SUBJECT: OPEN ISSUE ON SLOPE STABILITY

Open issue 7 of the Draft Technical Evaluation Report (DTER) for Atlas Corporation's (Atlas') proposed reclamation plan for uranium mill tailings at its Moab, Utah site, is the capability of the slopes of the disposal cell to endure geologic processes including settlement. In response to that issue, Atlas has provided additional information to the Nuclear Regulatory Commission including a report prepared by your consultant, Woodward-Clyde, "Evaluation of Potential Surface Deformation Related to Salt-Dissolution Subsidence at the Atlas Tailings Site, Moab, Utah" dated July 8, 1996. In that report, a procedure developed by Bray et al is used to evaluate potential deformation of the tailings pile surface.

Re: Evaluation of Potential Surface Deformation Related to Salt-Dissolution Subsidence  
at the Atlas Tailings Site, Moab, UT, 8 Jul 96, Woodward-Clyde Federal Services.

Figure A.

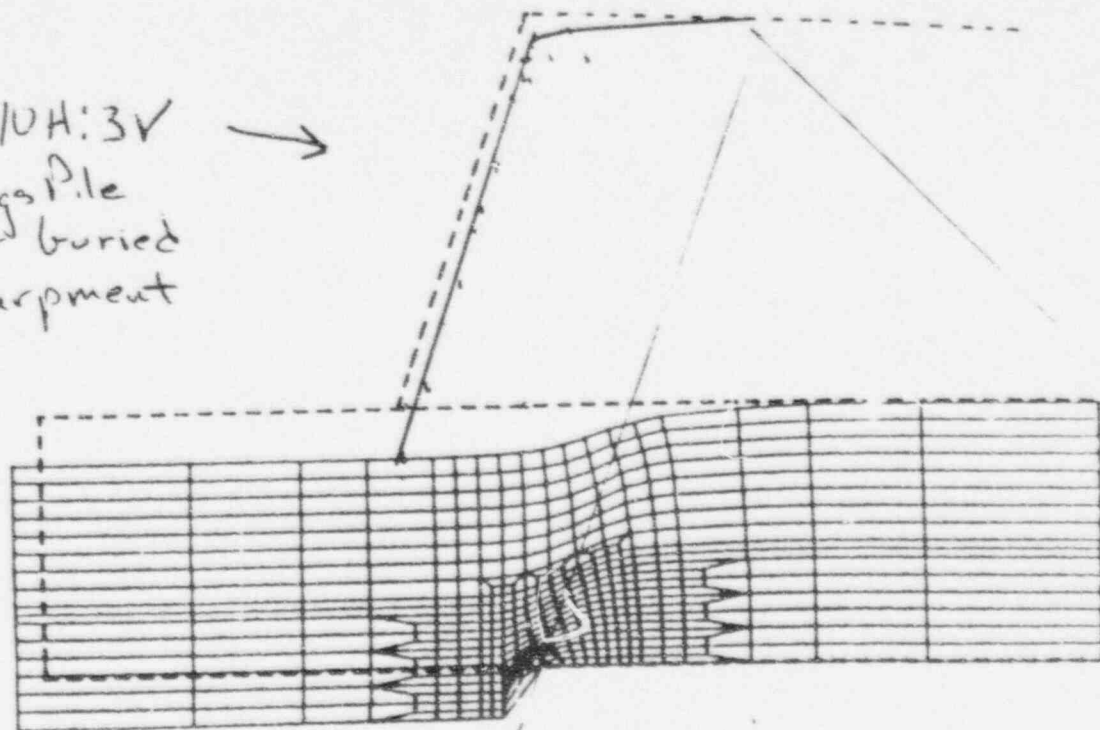
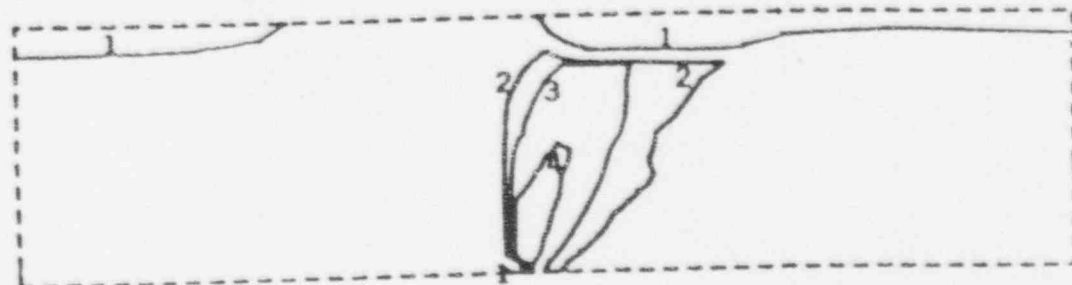
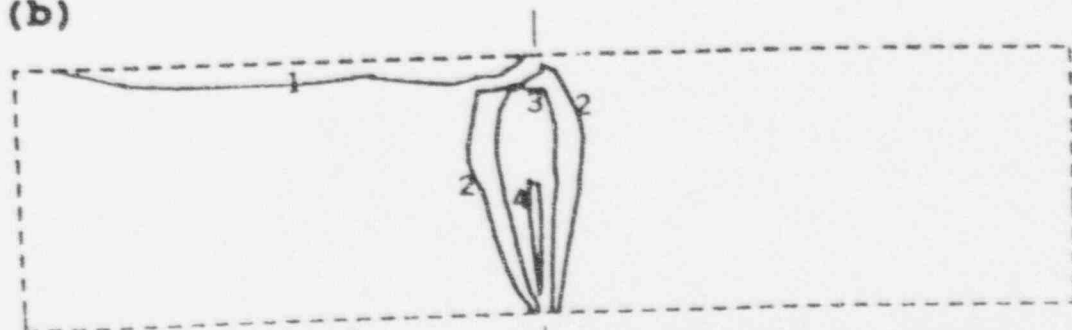
representative for the Atlas site because of the unconstrained free face of the the tailings pile with minimal lateral confining forces. (see attached figure A) The Bray model would be more applicable to subgrade disposal.

In conclusion, even though I question the unqualified absolute use of Bray's Finite Element Prediction model for this specific site; when one looks at the data presented, there are predictable ruptures in the 2 faces of the tailings pile where the pile intersects the plane of the buried escarpment. This does not support the report's final conclusion that the potential for differential offsets reaching the surface of the pile as a result of salt dissolution over the next 1000 years is negligible.

FIG. 7. Path of Normal Fault Rupture through Soil: (a) Stiff Earth Materials, Steep Dip; (b) Stiff Earth Materials, Shallow Dip; (c) Ductile Earth Materials

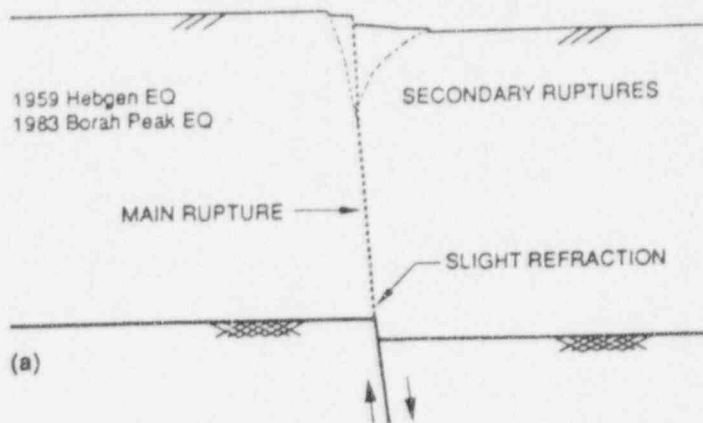
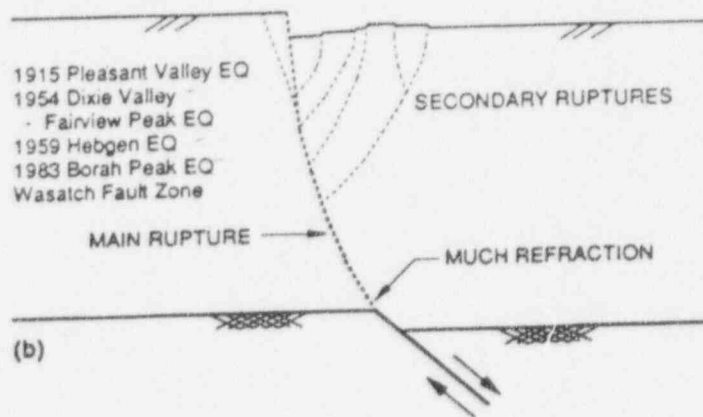
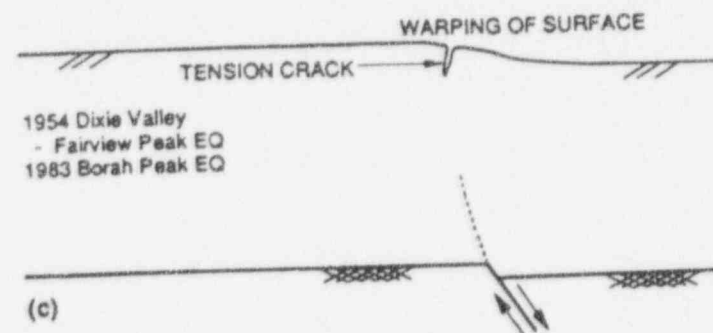
e.) The angle of dip of the fault plane is important to the corresponding area of surface displacement. What is the angle of dip of the fault plane at the Atlas site? (see Bray fig. 7)
